City of Surrey
PLANNING & DEVELOPMENT REPORT

File: 7918-0175-00

Planning Report Date: September 16, 2019

LOCATION: 2345 - Oak Meadows Drive

1 SITE LAYOUT
Scale: 3/32"=1'-0"

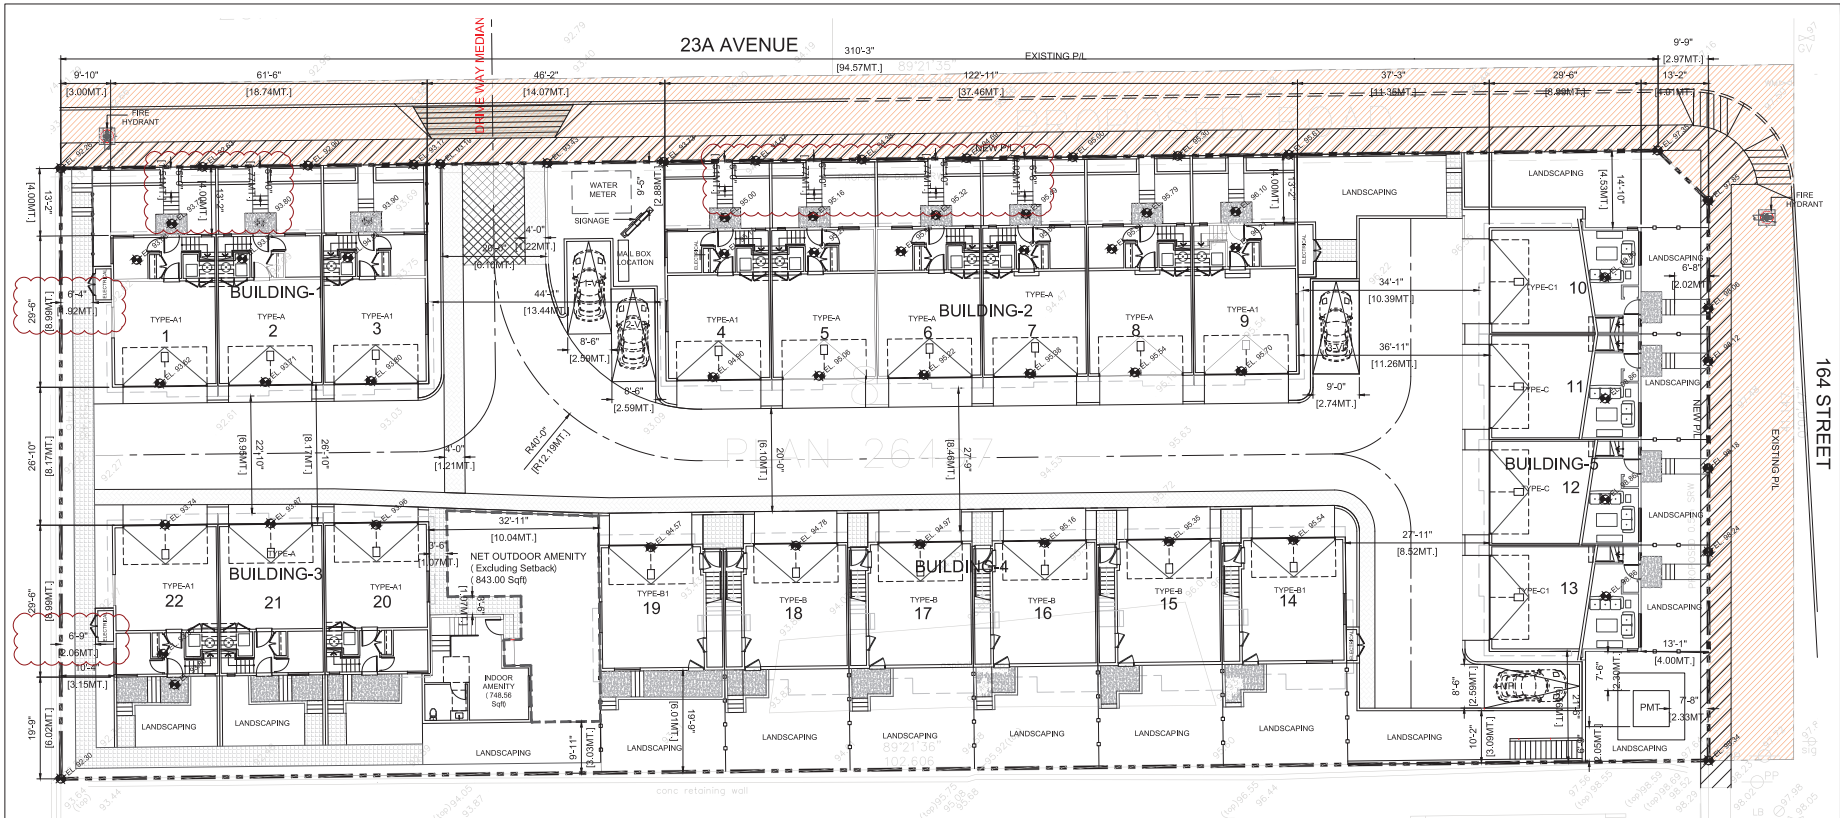
(a) Requested Variance:

- (a) to reduce the minimum north yard setback of the RM-30 Zone from 7.5 metres (25 ft.) to 4.5 metres (15 ft.) for Building 5, and to 4.0 metres (13 ft.) to building face and 1.5 metres (5 ft.) to stairs for Building 1 and 2;
- (b) to reduce the minimum east yard setback of the RM-30 Zone from 7.5 metres (25 ft.) to 4.0 metres (13 ft.);
- (c) to reduce the minimum south yard setback of the RM-30 Zone from 7.5 metres (25 ft.) to 6.5 metres (21 ft) for Building 5, 6.0 metres (20 ft.) for Building 4 and 3, and to 3.0 metres (10 ft.) for the Indoor Amenity Building; and
- (d) to reduce the minimum west setback of the RM-30 Zone from 7.5 metres (25 ft.) to 3.0 metres (10 ft.) for building face and 1.9 metres (6 ft.) to electrical closet for Building 1 and 3.

(c) Staff Comments:

- The proposed setbacks are considered reasonable from an urban design perspective as they achieve a more urban, pedestrian streetscape along 23A Avenue and 164 Street.
- The proposed setbacks are consistent with the setbacks that have been achieved in the local area.
- The west setbacks for Buildings 1 and 3 are side yard conditions and therefore should have minimal impacts on the rear yard privacy of the adjacent townhouse owners.
- The proposed south rear yard setbacks are appropriate, given that the existing townhouse units on the property to the south are oriented with their side yards adjacent to the subject site. Furthermore, a large portion of this setback is located adjacent to the indoor and outdoor amenity space of the adjacent site.

Schedule A

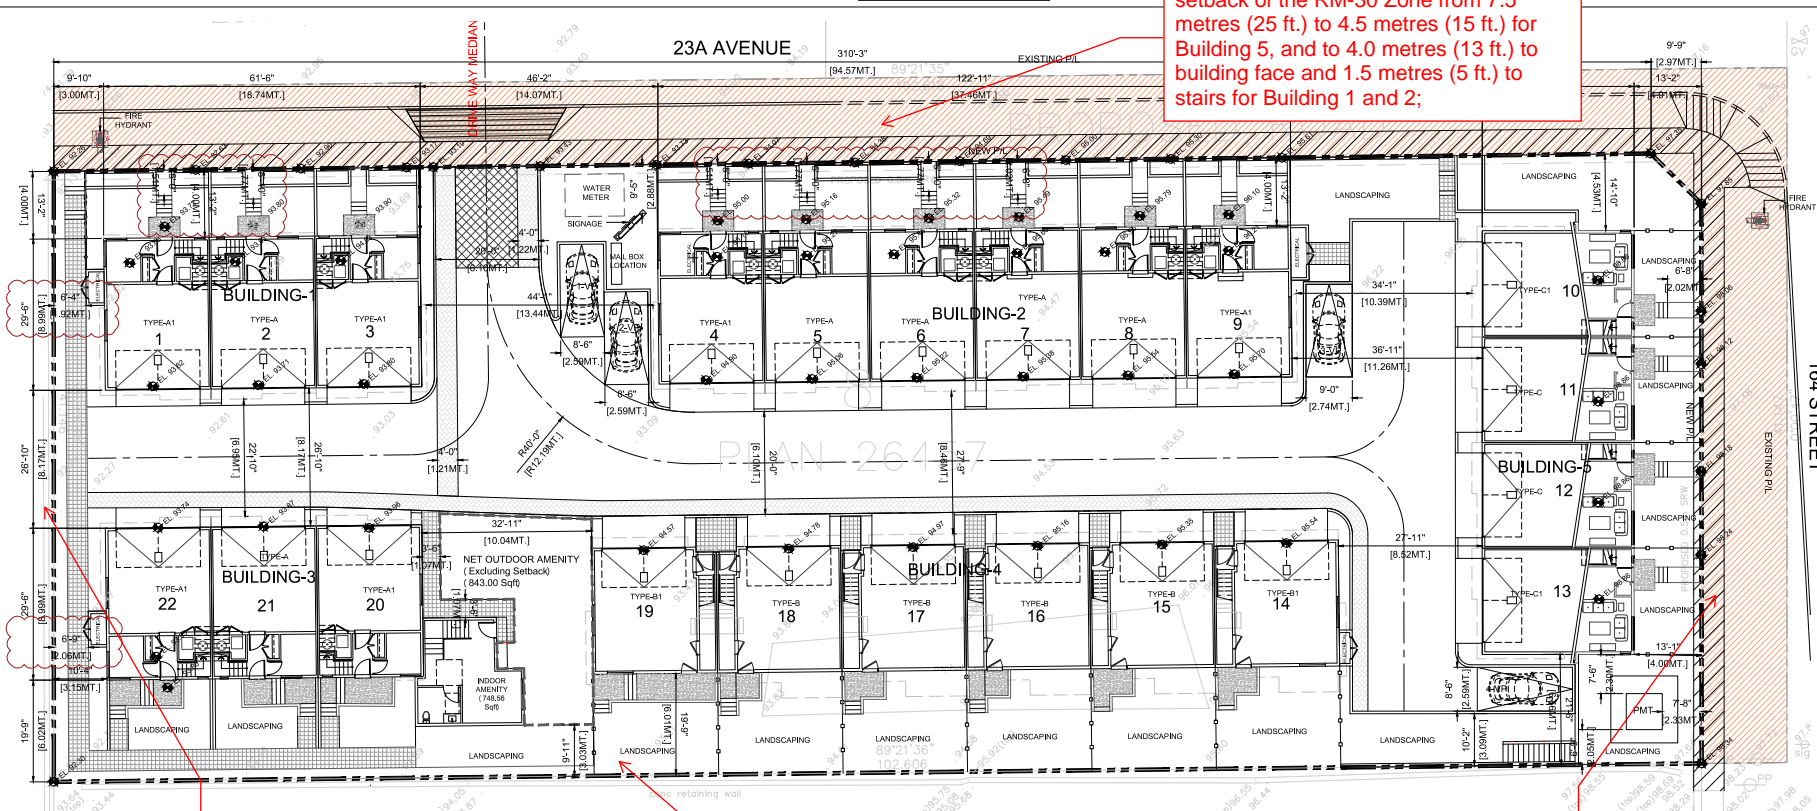
to reduce the minimum north yard setback of the RM-30 Zone from 7.5 metres (25 ft.) to 4.5 metres (15 ft.) for Building 5, and to 4.0 metres (13 ft.) to building face and 1.5 metres (5 ft.) to stairs for Building 1 and 2;

to reduce the minimum west setback of the RM-30 Zone from 7.5 metres (25 ft.) to 3.0 metres (10 ft.) for building face and 1.9 metres (6 ft.) to electrical closet for Building 1 and 3.

to reduce the minimum south yard setback of the RM-30 Zone from 7.5 metres (25 ft.) to 6.5 metres (21 ft.) for Building 5, 6.0 metres (20 ft.) for Building 4 and 3, and to 3.0 metres (10 ft.) for the Indoor Amenity Building; and

to reduce the minimum east yard setback of the RM-30 Zone from 7.5 metres (25 ft.) to 4.0 metres (13 ft.);
